Service Letter

Service Letter: No. 322

Subject: Engine Bleed Port Gasket - Engine Compartment Bleed Air System.

Applicability: Bell Model 407

Figure 1: Engine Compartment
Bleed Air System

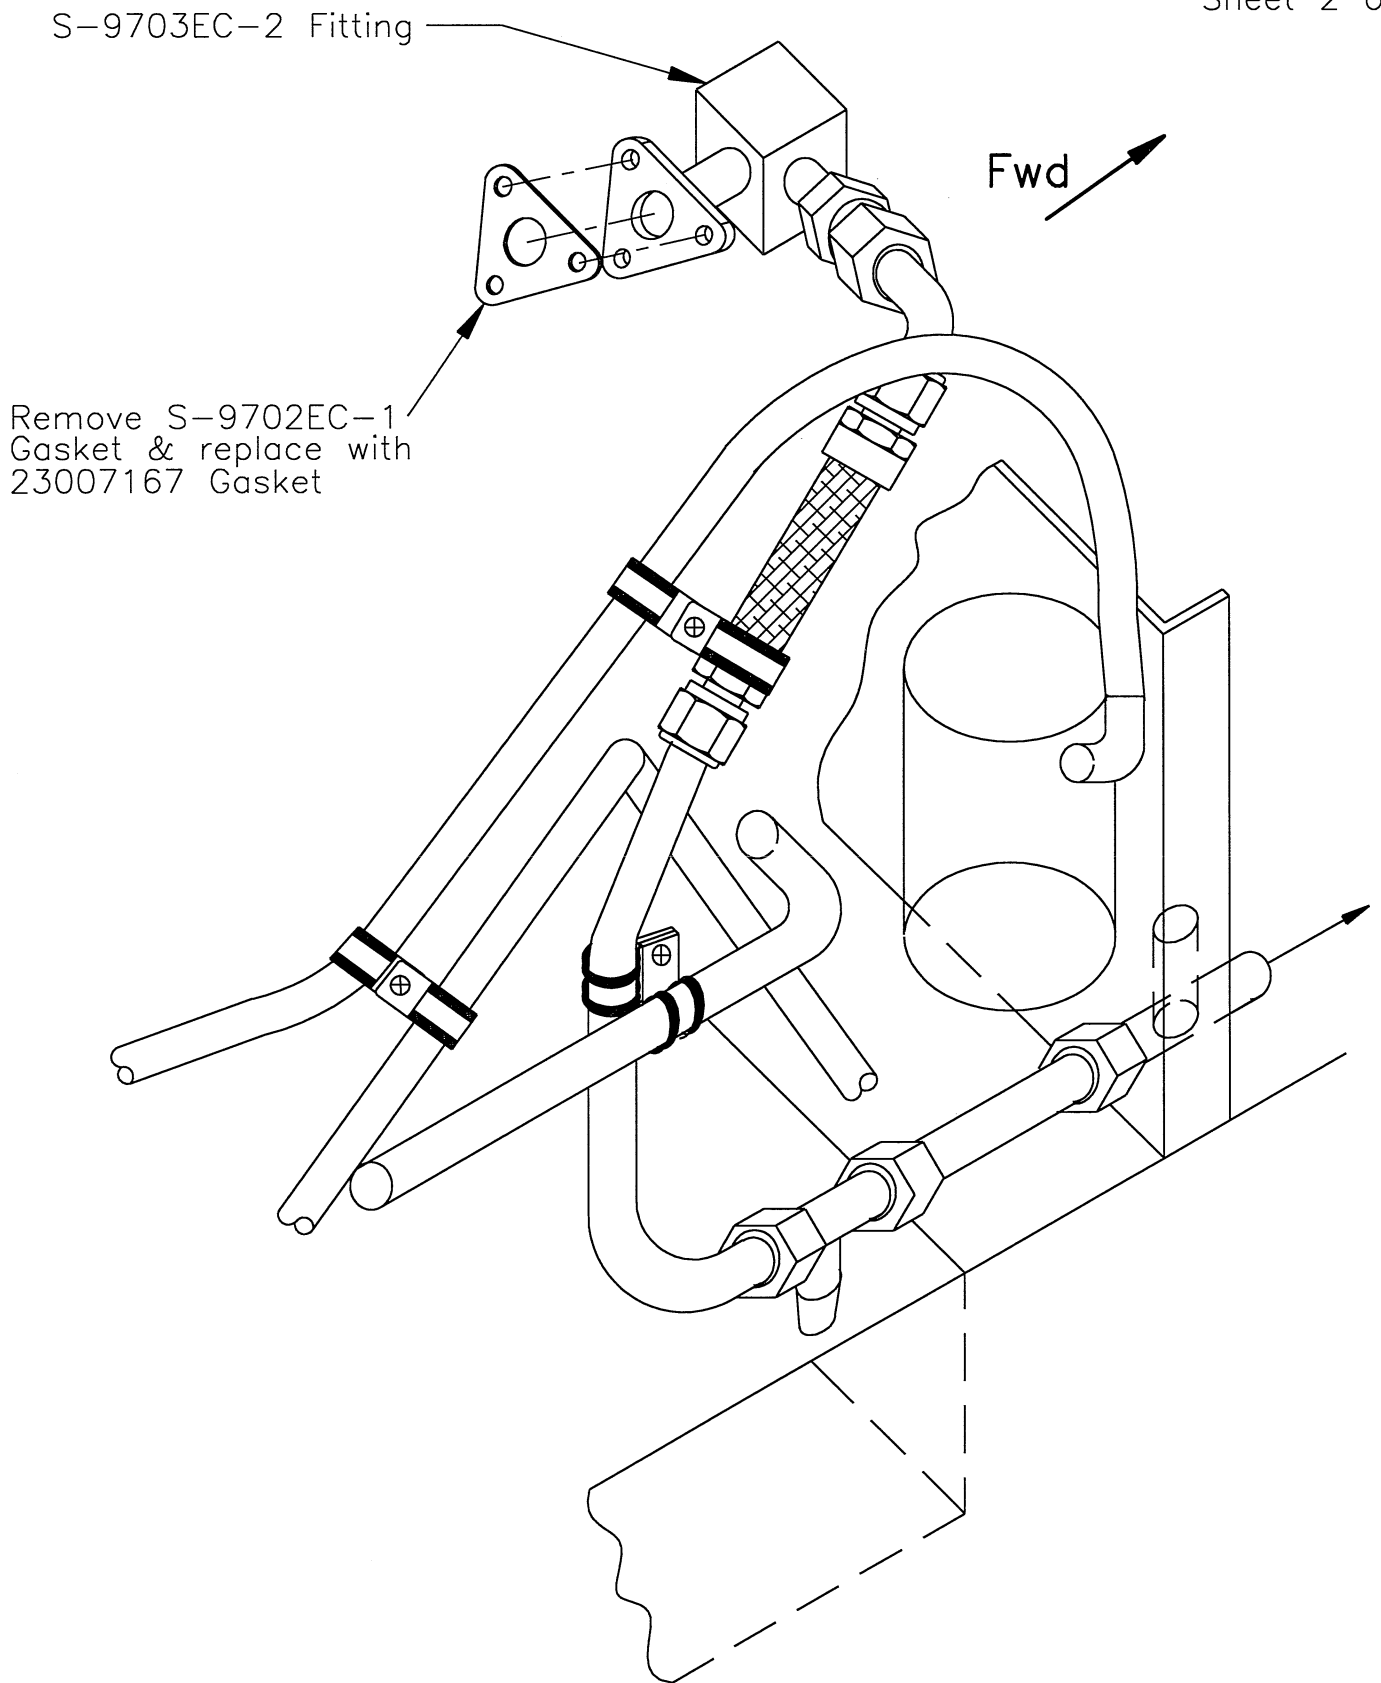
It has come to our attention that the S-9702EC-1 gasket, shipped with a small number of subject systems (8 units), may not provide a positive seal under all conditions. This document provides authorization and instructions for the removal and replacement of this gasket. Replacement gaskets are available from Air Comm Customer Service Department, telephone 303-440-4075.

Refer to figure 1. Remove retaining bolts from S-9702EC-2 fitting, and remove fitting and gasket. Replace with 23007167 gasket, install fitting and bolts and torque to specifications.
